FY 2018-19 Standard Plans Update Training

Index 102-100 (previously Index 415) "Temporary Barrier"

Index 102-100 (previously Index 415) "Temporary Barrier"

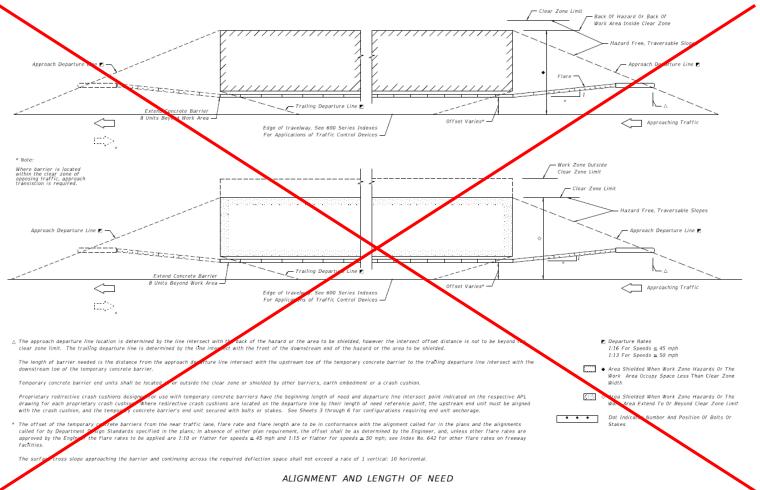
Length of need has been removed from the index. See the Standard Plan Instructions for length of need calculations.

Index 102-100 (previously Index 415) "Temporary Barrier"

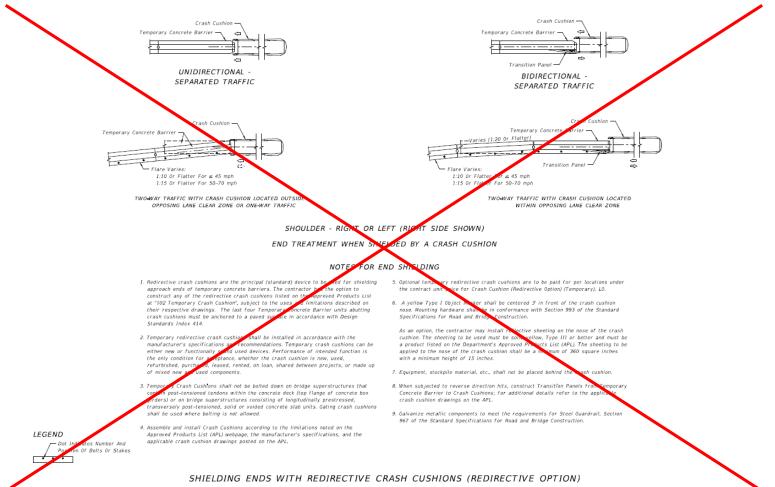
Crash cushion details have been moved to Index 102-110. See APL drawings for crash cushion details related to proprietary barriers.

Index 102-600 (previously Index 600) "General Information for Traffic Control Through Work Zones" Sheet 12 of 12

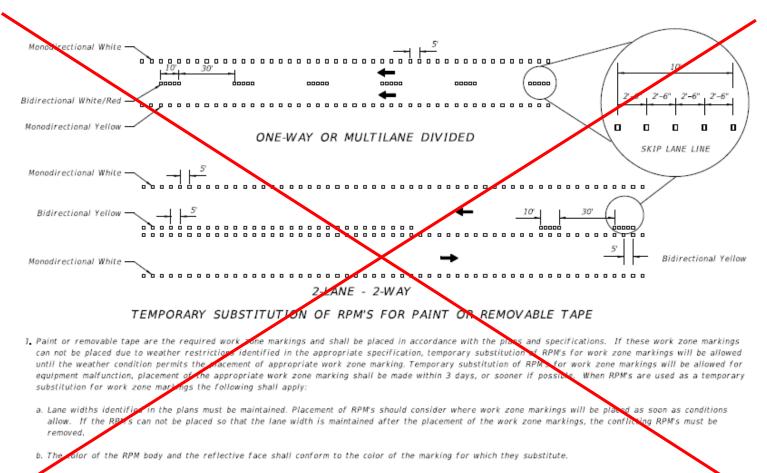
Removed Temporary Substitution of RPM's for Paint or Removable Tape.

Index 102-606 (previously Index 606) "Two-Lane, Two-Way, Work Within the Travel Way – Signal Control"

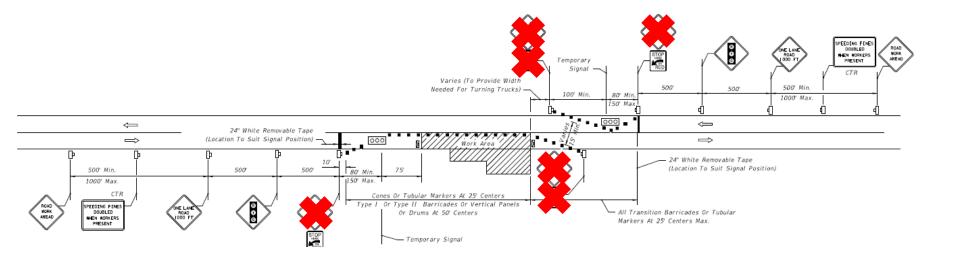
Removed "Reverse Curve" and "Keep Right" signs from all sheets.

Index 102-660 (previously Index 660) "Pedestrian Control for Closure of Sidewalks"

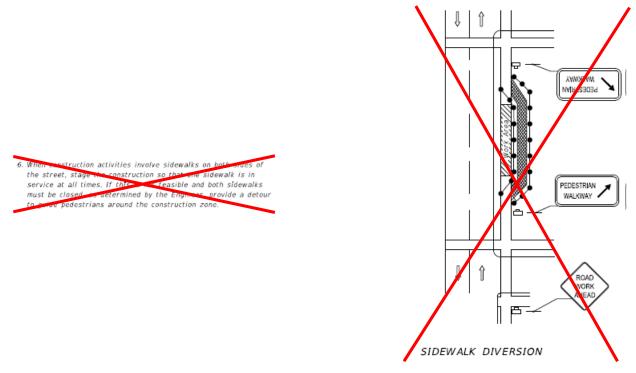
- Revised "General Notes". The most significant change being shown below.
- Revised "Sidewalk Diversion" detail to show temporary sidewalk instead of a diversion into the traveled way. A diversion into the traveled way is still allowed, but the feasibility is limited.

Index 546-010 (previously Index 518) "Ground-In Rumble Strips"

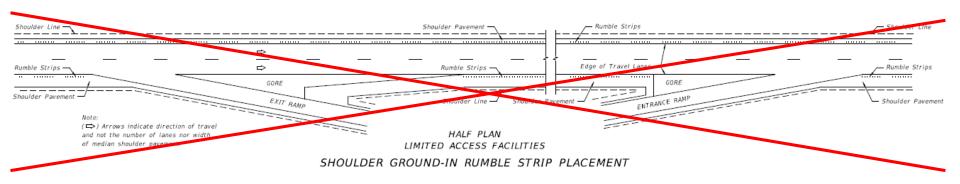
As part of the effort to remove design information from the Standard Plans, the "Shoulder Ground-In Rumble Strip Placement" detail has been removed and placed into the FDM 211.4.4. For the time being, the placement details are also described in the "General Notes".

Index 546-010 (previously Index 518) "Ground-In Rumble Strips"

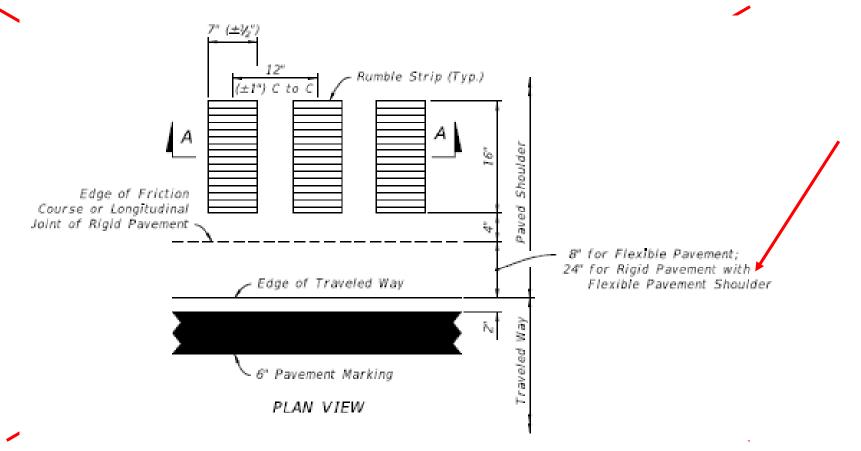
The concrete pavement details on the old sheet 2 of 2 have been removed. The "Rigid Pavement with Flexible Pavement Shoulder" detail has been incorporated into "Detail 'A'" of the Standard Plan. The Profiled Thermoplastic criteria has been moved to FDM 211.4.4.2.

Index 665-001 (previously Index 17784) "Pedestrian Detector Assembly Installation Details"

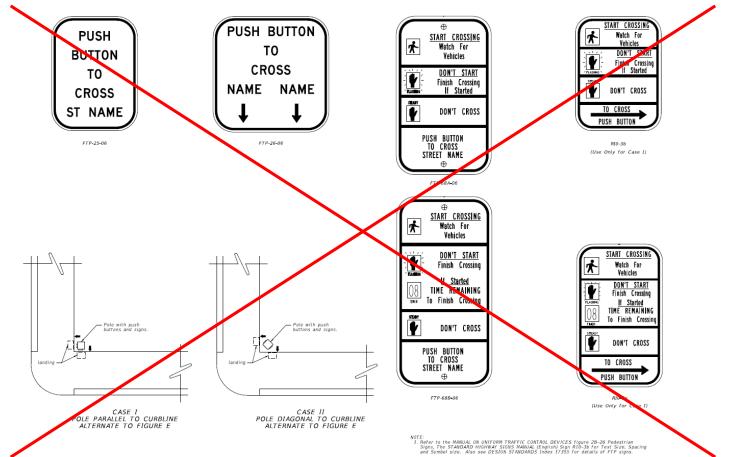
- The entire Index has been reconfigured, but, in general, the content is the same.
- Removed sheet with sign details and pushbutton location details (old sheet 2 of 2).

Index 700-010 (previously Index 11860) "Single Column Ground Signs" Sheet 5 of 9

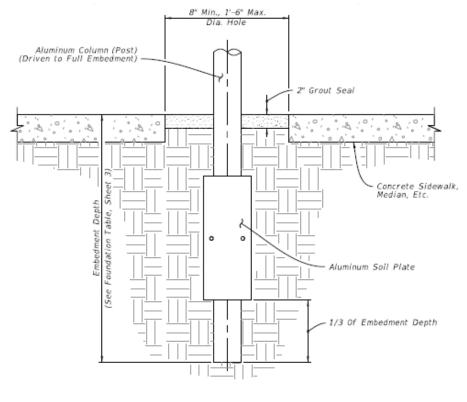
- Removed "Concrete/Stub Detail".
- Revised "Driven Post Detail".

Index 700-020 (previously Index 11200) "Multi-Column Ground Sign" Sheet 1 of 3

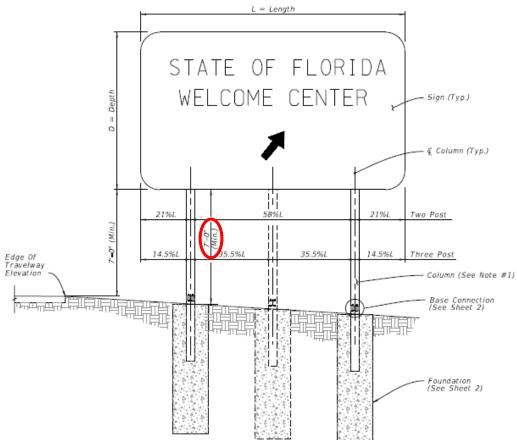
- > Deleted 8' (Max.) requirement.
- Added 7' (Min.) requirement for length of post from base connection to bottom of sign panel.

Index 700-101 (previously Index 17302) "Typical Sections for Placement of Single & Multi-Column Signs"

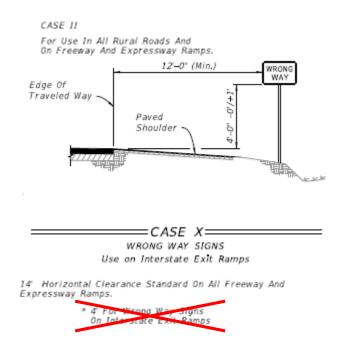
- There are Index-wide changes for consistency, but most are relatively minor.
- Removed wrong way sign criteria out of the "Case II" detail and created a "Case X" detail specifically for wrong way signs.

Index 706-001 (previously Index 17352) "Typical Placement of Raised Pavement Markers"

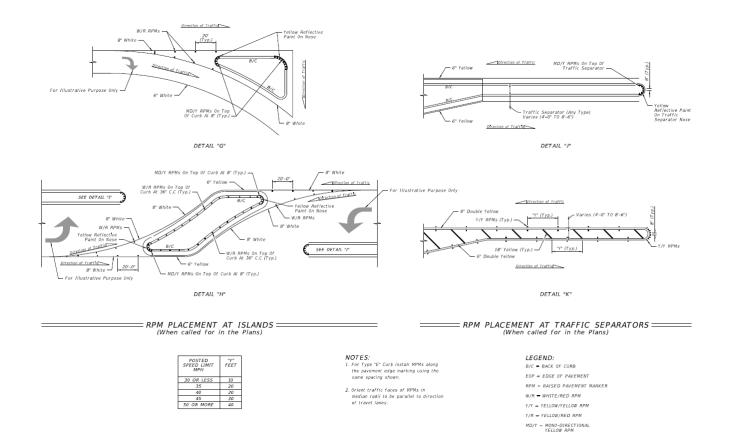
- There are Index-wide changes, but most are relatively minor (e.g., "Reflective" to "Raised", note changes, etc.).
- Two new sheets have optional RPM details for median openings, islands, and traffic separators that, if used, should be called for in the Plans.

Index 711-001 (previously Index 17346) "Pavement Markings"

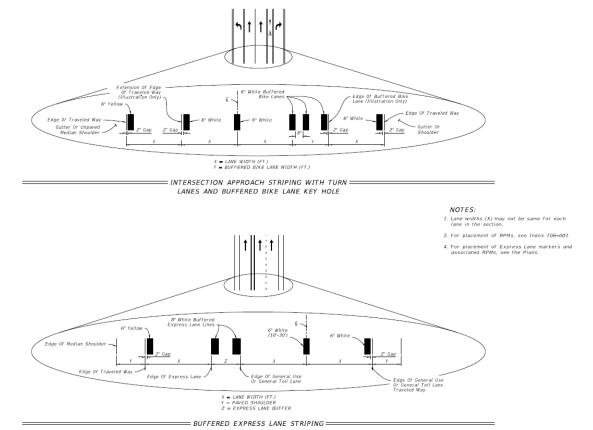
- There are Index-wide changes for consistency, but most are relatively minor.
- > Two new sheets have been added to clearly show longitudinal markings.

Index 711-001 (previously Index 17346) "Pavement Markings"

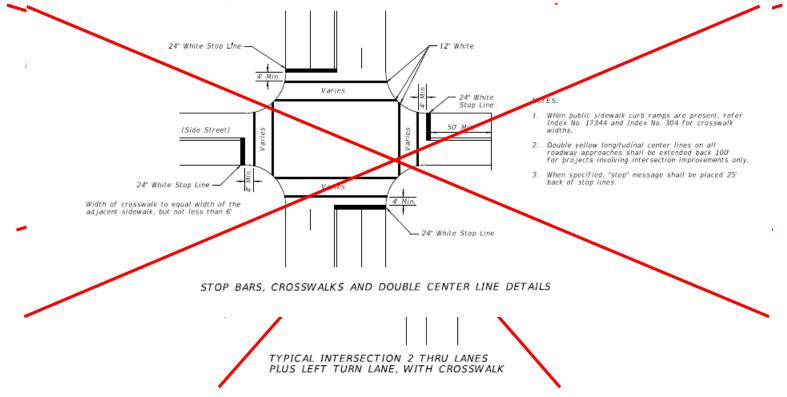
- Removed the following details:
 - "Typical Crosswalk Markings for Curb Ramps" on sheet 6 of 17 (old)
 - "Restricted Left Turn Marking" on sheet 7 of 17 (old)
 - "Typical Intersection 2 Thru Lanes Plus Left Turn Lane, with Crosswalk" on sheet 7 of 17 (old)
 - "Stop Bars, Crosswalks and Double Center Line Details" on sheet 7 of 17 (old)

Index 711-001 (previously Index 17346) "Pavement Markings"

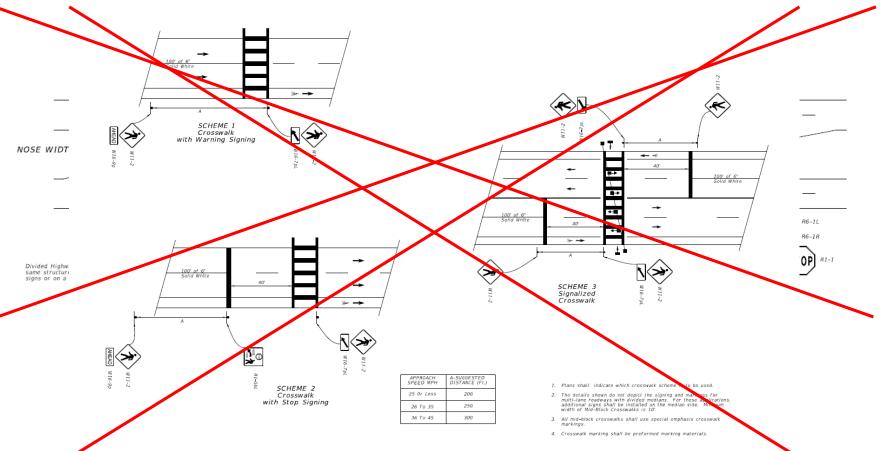
- Removed the "One-Way Signs on Divided Highway Intersections" detail on sheet 8 of 17 (old) placed it in FDM 230 as an exhibit.
- Removed the sheet with Midblock Crossing details (old sheet 13 of 17) and placed it in FDM 230 as an exhibit.

Index 711-001 (previously Index 17346) "Pavement Markings"

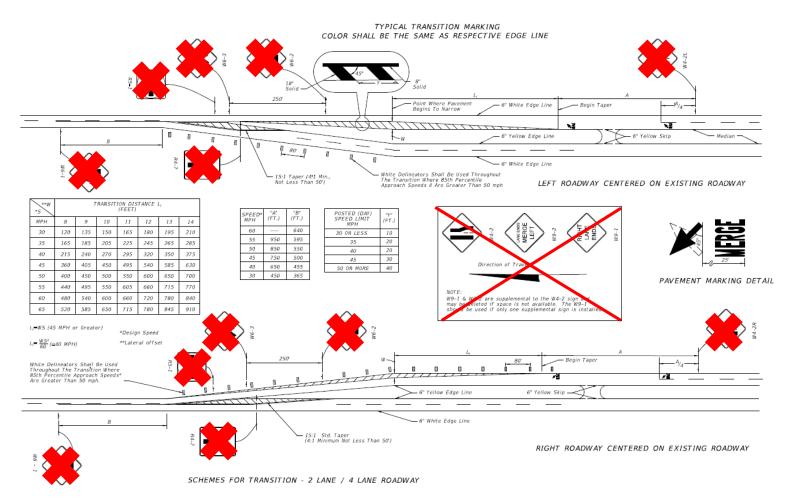
Removed the signing details from "Schemes for Transition – 2 Lane / 4 Lane Roadway" on sheet 9 of 17 (old) and placed them in FDM 230 as an exhibit.

Index 711-001 (previously Index 17346) "Pavement Markings"

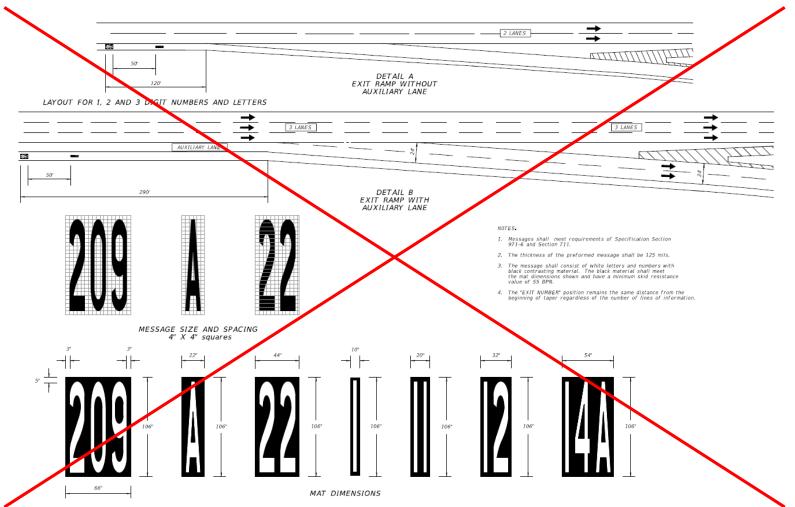
Removed sheet with exit number details (old sheet 10 of 17) and placed it in Index 711-003.

Index 711-001 (previously Index 17346) "Pavement Markings"

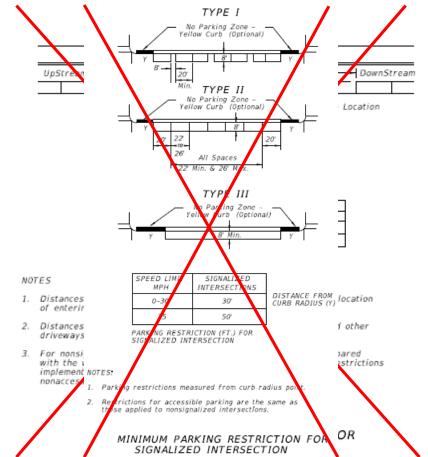
- Removed the following details from sheet 15 of 17 (old):
 - "Minimum Parking Restriction for Nonsignalized Intersections"
 - "Minimum Parking Restriction for Signalized Intersection"
- See FDM 212.11.5 for on-street parking at intersections.

Index 711-001 (previously Index 17346) "Pavement Markings"

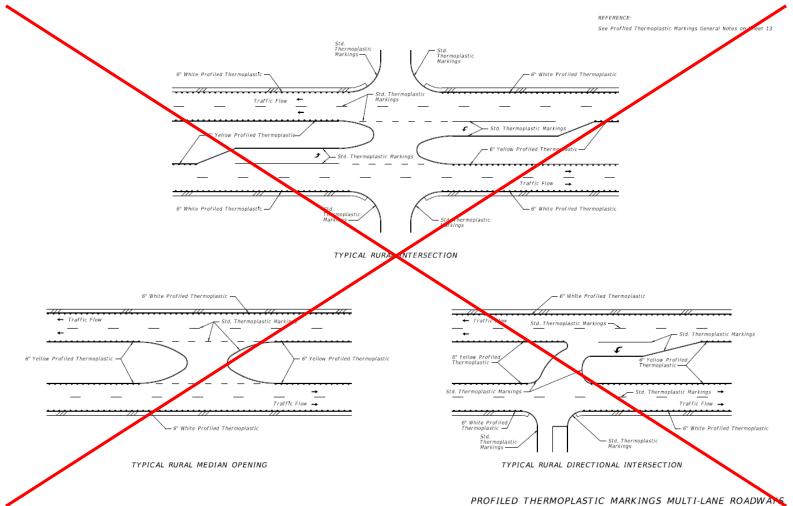
Removed sheets with Profiled Thermoplastic details (old sheets 16-17 of 17). See FDM Figure 210.4.4 for the placement of audible and vibratory treatment.

Index 711-002 (previously Index 17347) "Bicycle Markings"

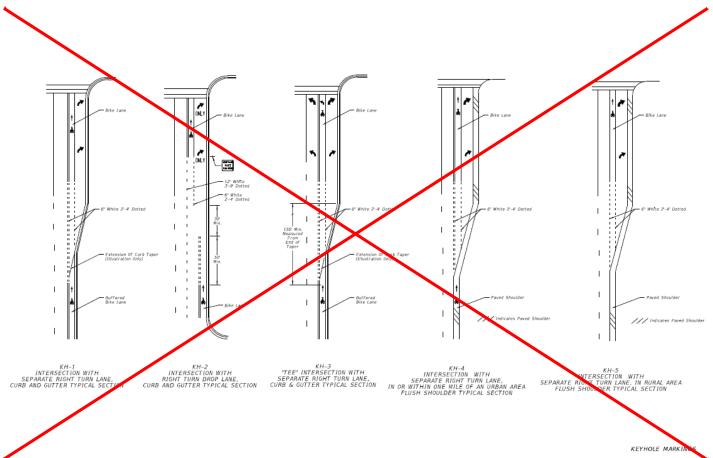
- Removed sheet with "Shared Lane Markings" details (previously sheet 2 of 5). See FDM 223.3 for guidance on Shared Lane Markings.
- Removed sheets with bike lane typical layouts (previously sheets 4-5 of 5). See FDM 223 exhibits for updated bike lane typical layouts.

Index 711-003 (previously Index 17345) "Interchange Markings"

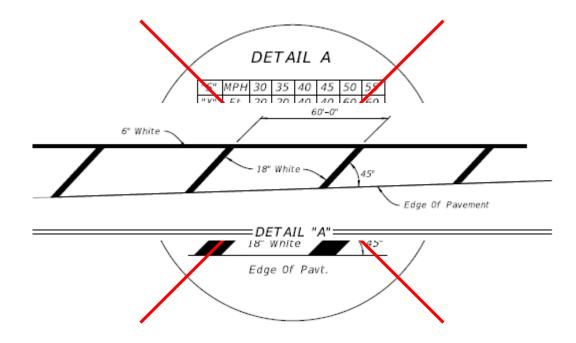
- > There are Index-wide changes for consistency, but most are relatively minor.
- Revised the chevron spacing chart on sheet 1 of 1. All chevron spacing is now 60'.

Index 711-003 (previously Index 17345) "Interchange Markings"

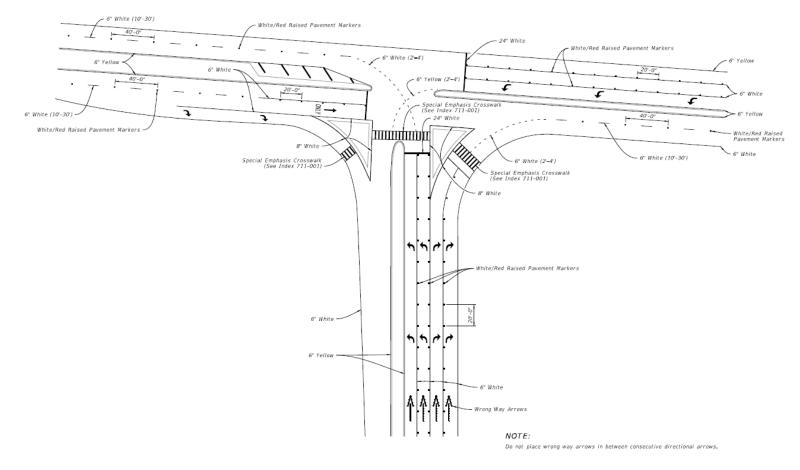
> Added new sheet with a interchange intersection (sheet 6 of 7).

Index 711-003 (previously Index 17345) "Interchange Markings"

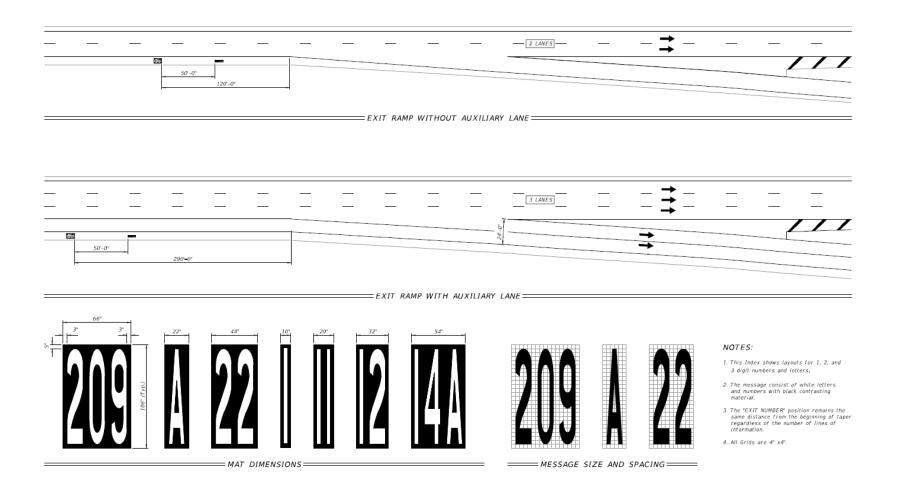
Added new sheet with exit number details (sheet 7 of 7).
